THE CITY OF READING

ADDENDUM NO. 2 BID :

11th and Pike Playground

Phase II Improvements

Exhibit A – 2015-08-11_Addendum 2 – Fence Clarification-ATTACHMENT

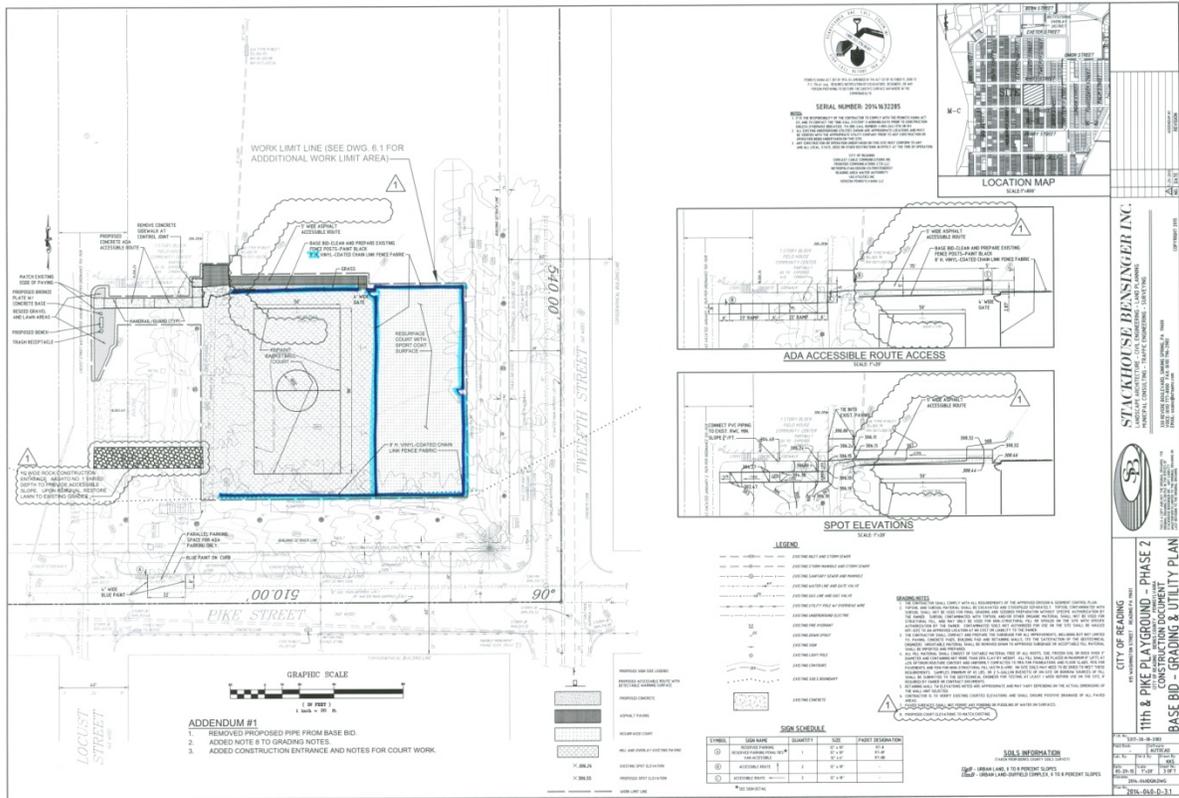
Q3. Please clearly indicate the fence layout in base bid and alternate 1.

A3. See attached Clarification Sketches.
